Model: Moto Guzzi 1200 8V engines

Subject: Operations on valve bucket tappets

KIT A: P/N 1A002060

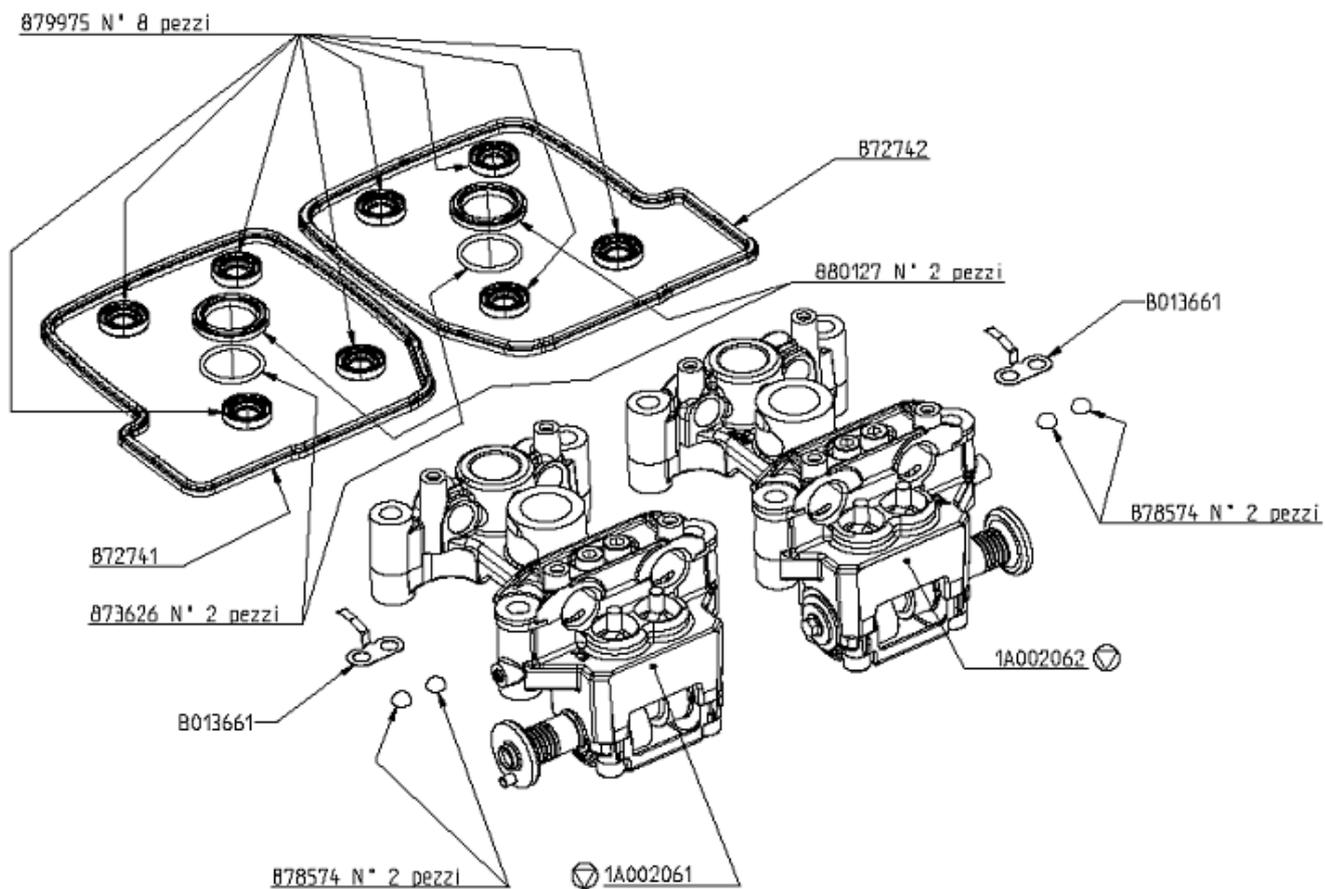
To verify whether the vehicle can be modified with **kit A** remove the timing cover and check whether it is the floating type, which can be recognised by the presence of the circlip in the spark plug hole area:

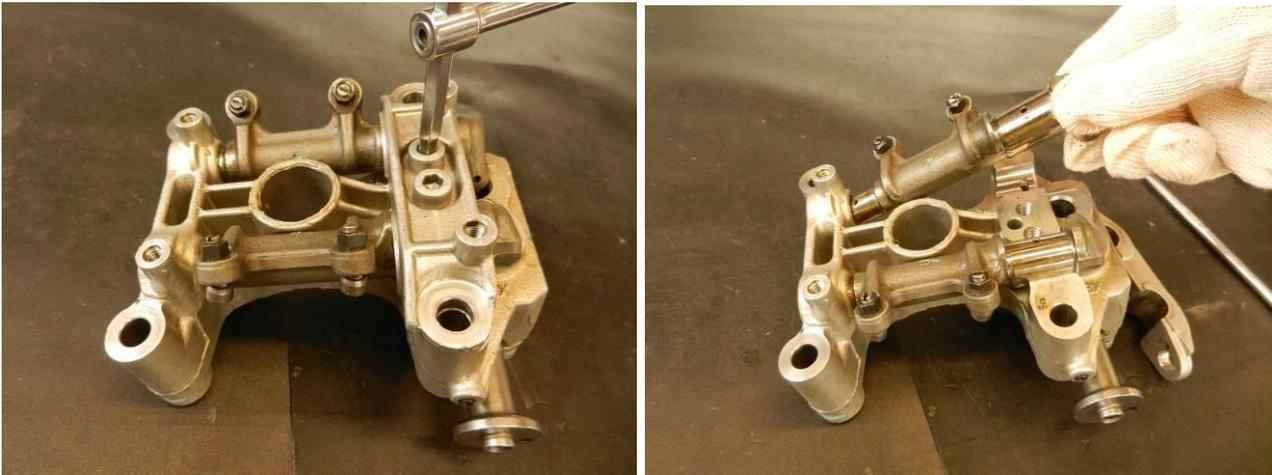
As per Workshop Manual procedure, access the timing system by removing the cylinder head cover, paying attention to the internal gaskets; remove the timing gear from the camshaft and then remove the timing system cam tower.

Remove the rockers mount and delicately slide them from their seat.

Place the pads P/N 878524 in the relative seats with the aid of a layer of grease so that they hold the position.

Fit the old rockers in the **new** cam tower, fasten the rocker retainer cap, installing the **new** ground plate **part No. B013661** between the retainer cap and the fastener screws (tightening torque 18 Nm);
